CHANGE ORDER FORM

Reference: Change Order Request for PARK_1912 – Washington Park Pump Station and Force Main

WASHINGTON PARK PUMP STATION AND FORCE MAIN
PAVEMENT RESTORATION - SHEET 2

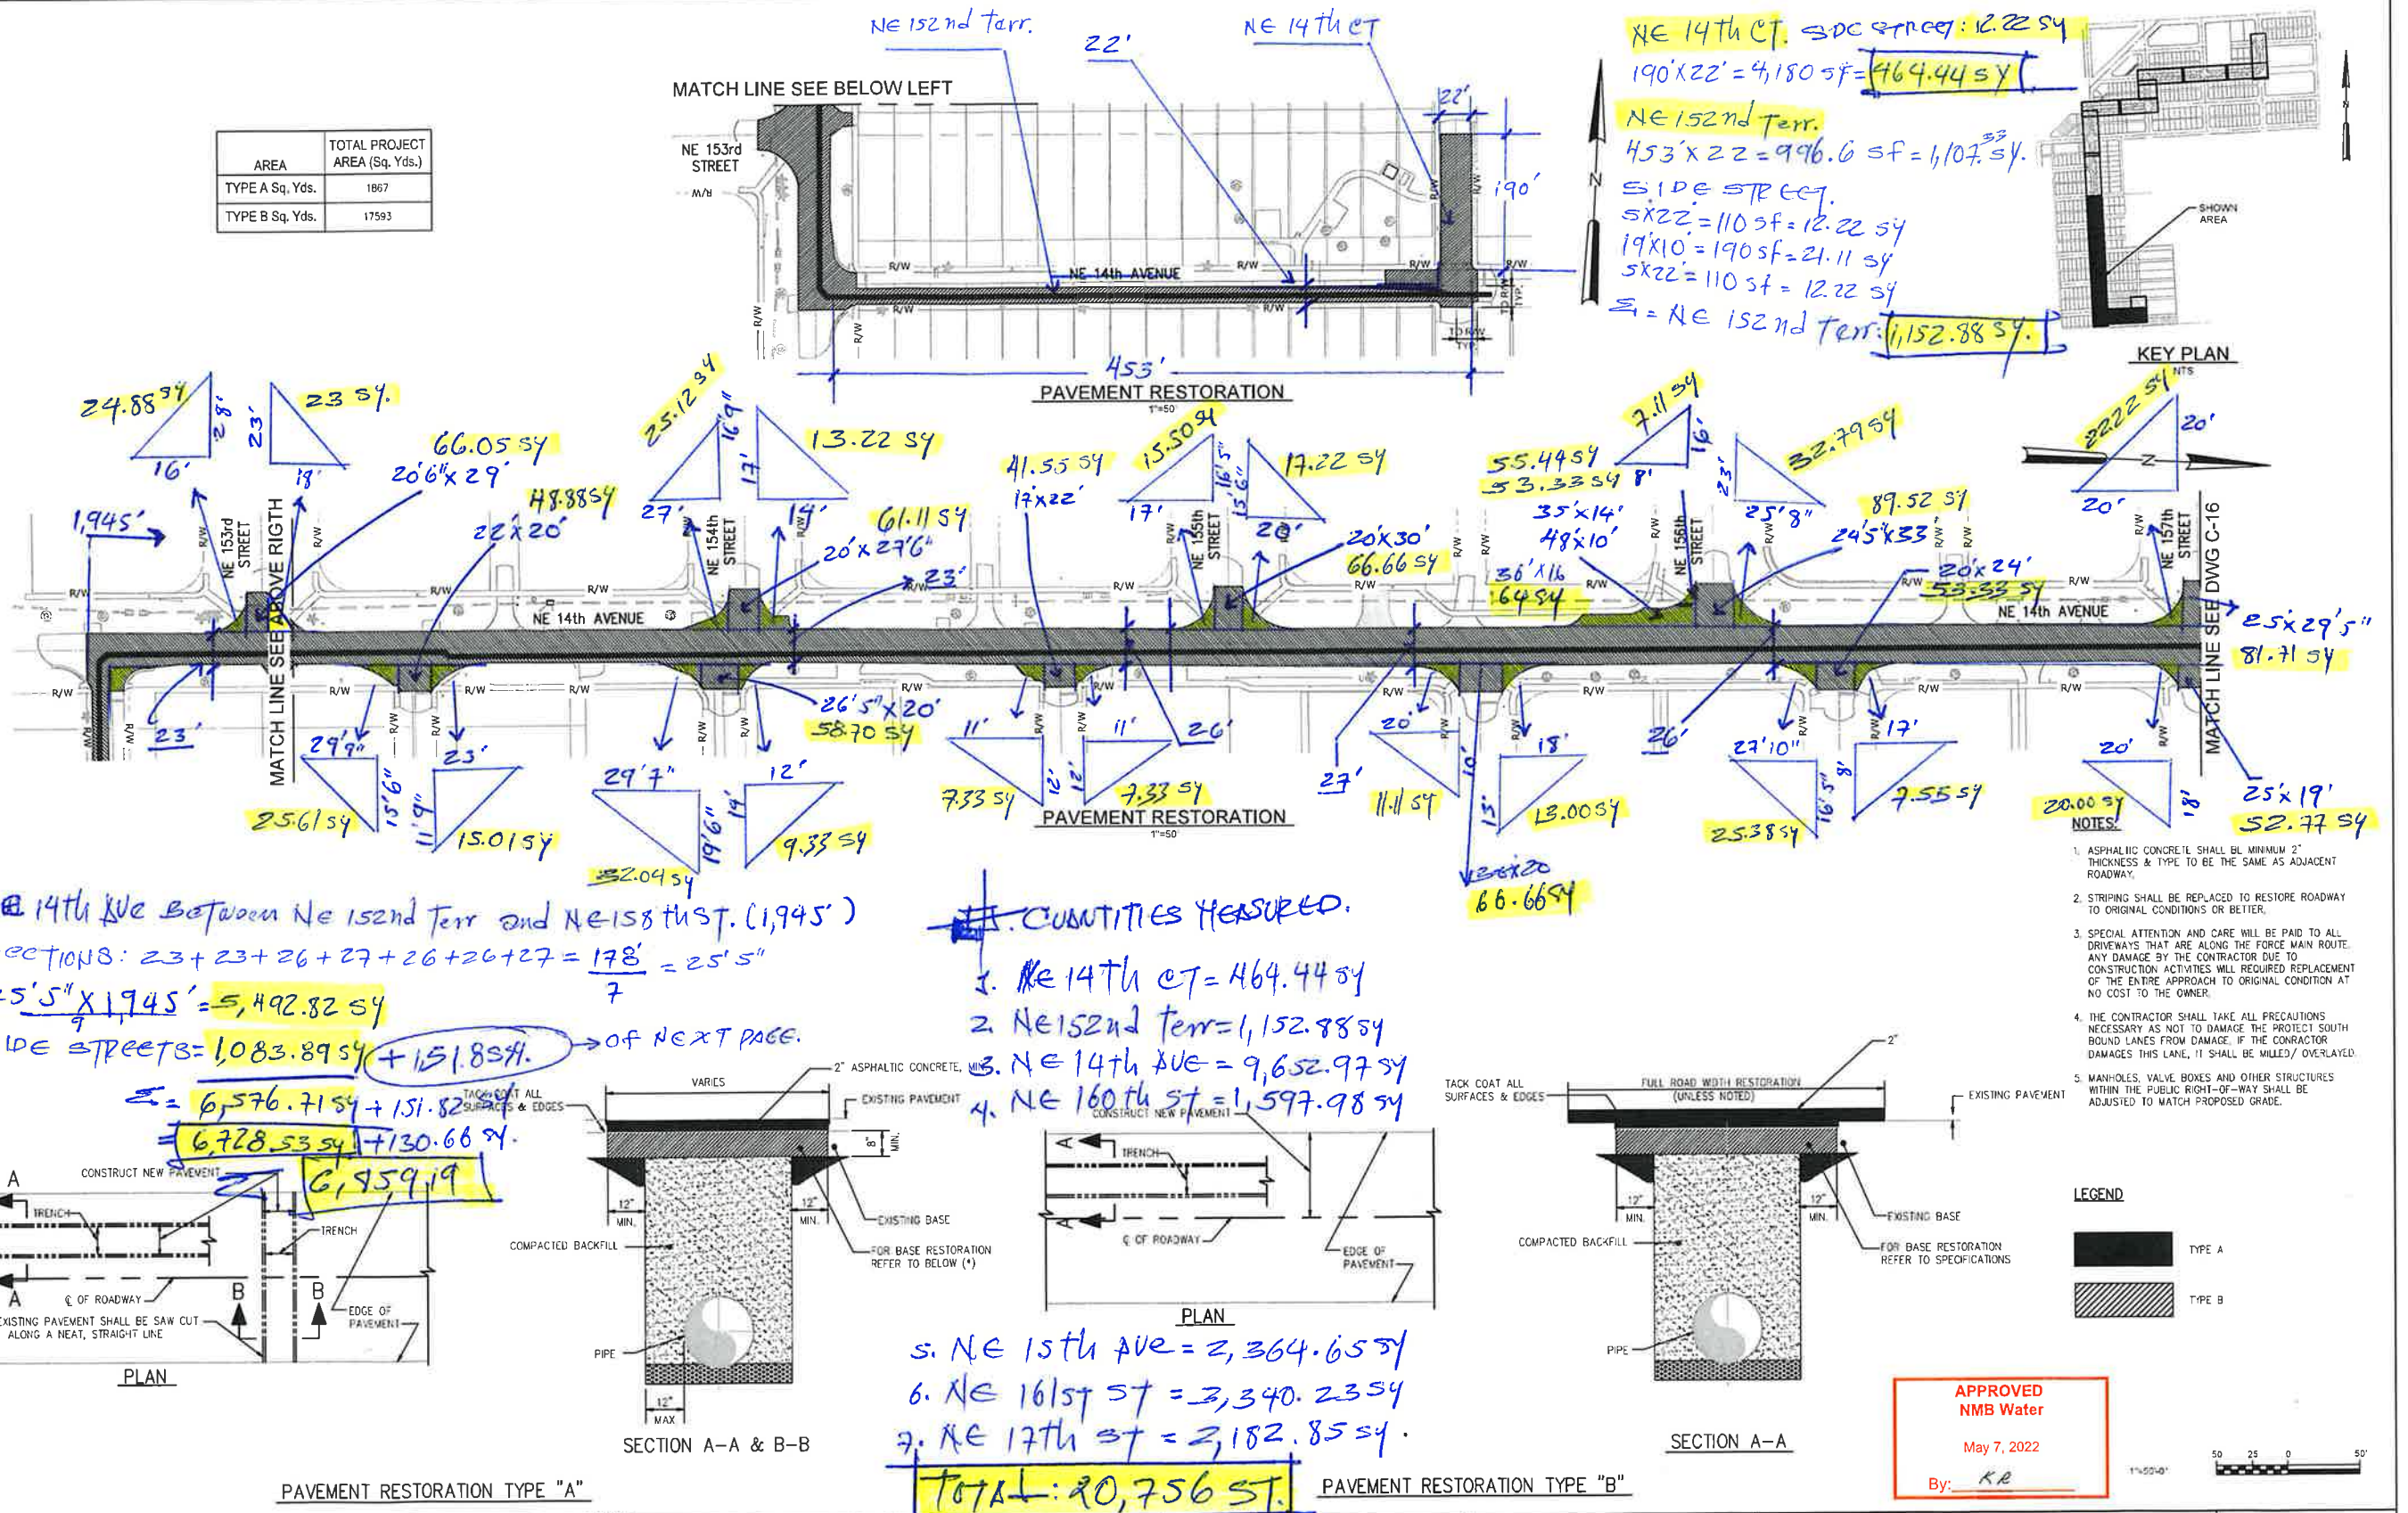
- **17,563 SY** for Items #9 and #10
- Upon commencement of work, actual field measures revealed the need for increased quantities to meet the design intent and ensure a safe and functional working area. Specifically:
 - Items #3 and #4 were over-quantified in the contract documents. Revised quantities were measured at **5,795 LF** each, based on the actual linear footage of pipe installed.
 - Items #7 and #8 were under-quantified in the contract documents. Revised quantities were measured at **2,767 SY** each, based on the actual linear footage and trench width as per contract specifications.
 - Items #9 and #10 were measured at **20,756 SY** of actual mill and overlay (see attached sketch for reference).
- These changes were reviewed and discussed with the Project Engineer and are supported by field documentation, including daily reports, quantity tracking logs, and updated drawings.

SECTION B:

$$27' + 31'8'' + 37' + 38'7'' + 34' + 24' + 22' + 23' = 237'3''$$

$$\frac{8}{29'7''} = 29'7''$$

$$29'7'' \times 28'5'' = 841.25 \text{ SF}$$

$$\text{LONG: } 28'5'' + 36'3'' = 64'8''$$

$$\frac{64'8'' \times 29'7''}{9} = 2,130 \text{ SF}$$

$$\text{SIDE STREETS} = 663.78 \text{ SF}$$

$$+ 2,130.00 \text{ SF} = 2,793.78 \text{ SF}$$

$$\text{LONG: } 37' + 33' + 30'5'' + 22' + 25'8'' = 148'1'' = 29'7''$$

$$\frac{404'6'' \times 29'7''}{9} = 1,329.60 \text{ SF}$$

$$\text{SIDE STREET: } 430.10 \text{ SF}$$

$$\text{PARKING LOT: } 418.61 \text{ SF} + 4.54 \text{ SF}$$

$$= 2,178.31 \text{ SF}$$

$$= 2,182.85 \text{ SF}$$

The total cost associated with the updated quantities is \$ 147,384.00, which reflects unit prices as established in the original contract. No changes to unit rates have been made.

To cover the additional work, we will need to utilize the \$40,000.00 Allowance and \$50,000.00 for Unforeseen Conditions. In addition to the \$ 90,000.00, we must prepare a Change Order in the amount of \$57,384.00 to account for the remaining overage due to updated quantities. Kindly proceed with preparing a Contract Amount Change Order for \$57,384.00, which should reflect the updated PO amount of \$5,511,749.00.

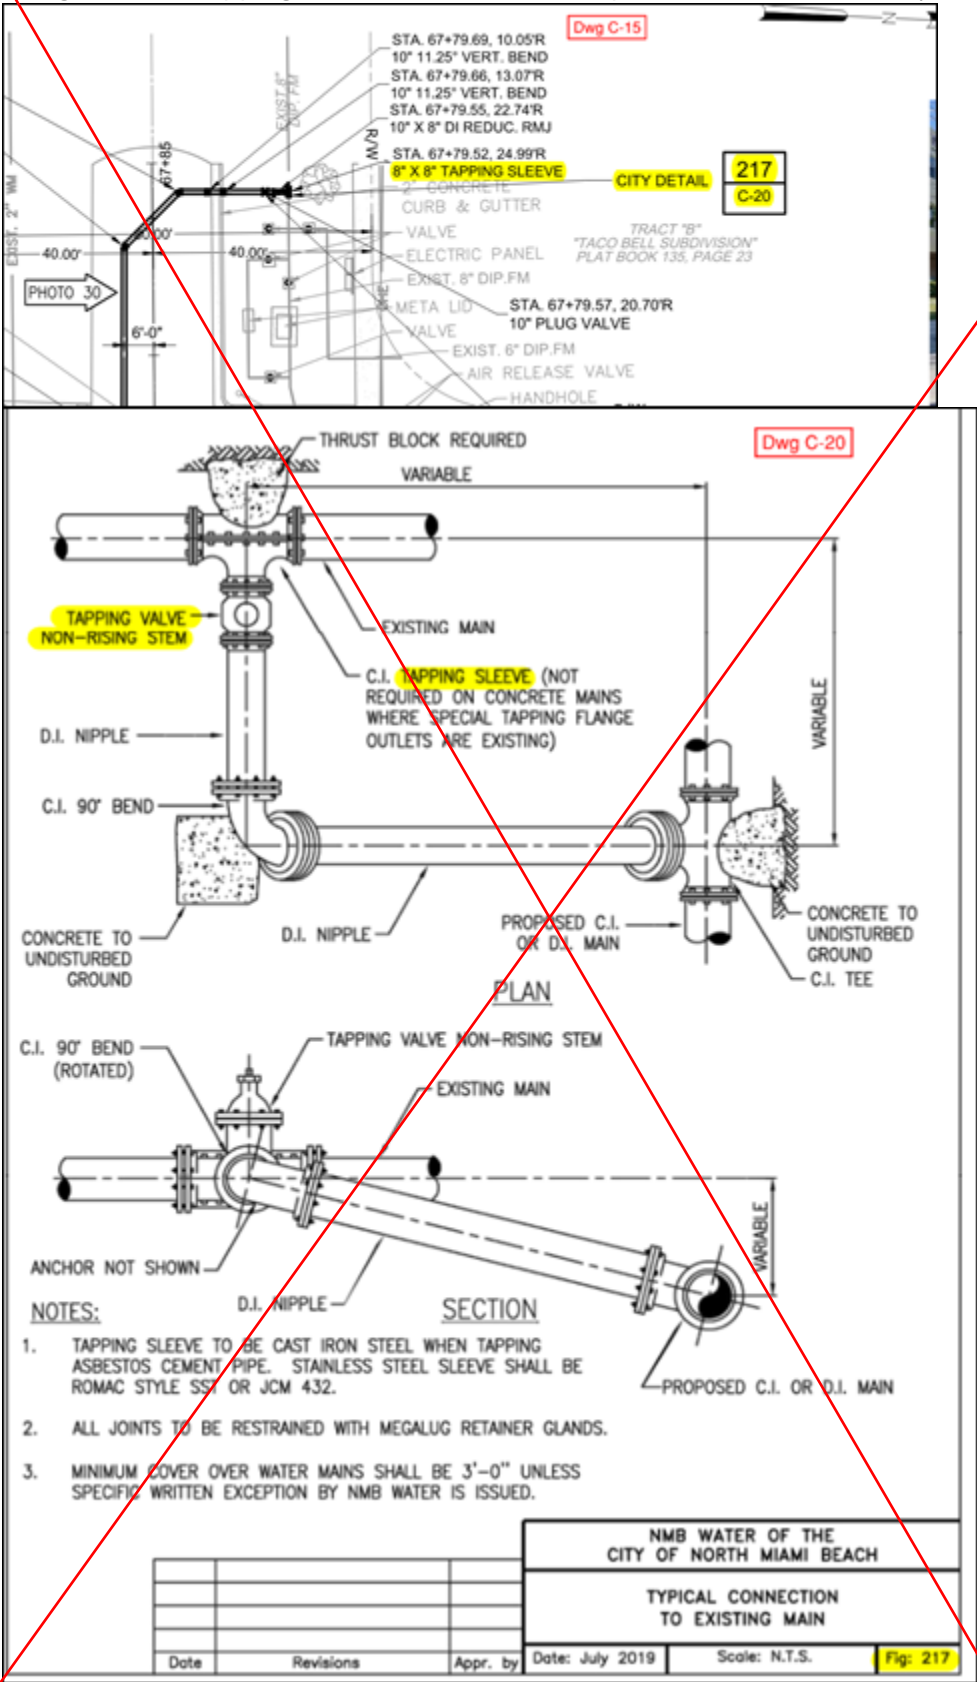
The primary items are as follows: an 8-inch limerock base for Type A permanent repair over the trench, and a 2-inch asphalt Type A permanent repair over the trench.
The contract specifies quantities of 1,867 square yards. However, a quick calculation indicates that by multiplying the length of the pipe (all of which is in the road) by the width of the trench, approximately 4 feet, the total is 2,588 square yards. This results in an additional 721 square yards, which is an increase of over 38% from the contract quantities.
The second item pertains to the addition of an 8-inch tapping sleeve, which was omitted at the connection point as shown on page C-15.

We reviewed the Type A pavement restoration quantities with our CAD team and we are in agreement with Hector’s estimate of ±2,588 square yards. As is typical, payment would be based on the actual quantities furnished.

In regard to the tapping sleeve, it is shown in the plans on C-15 and C-20 (see screenshots below).
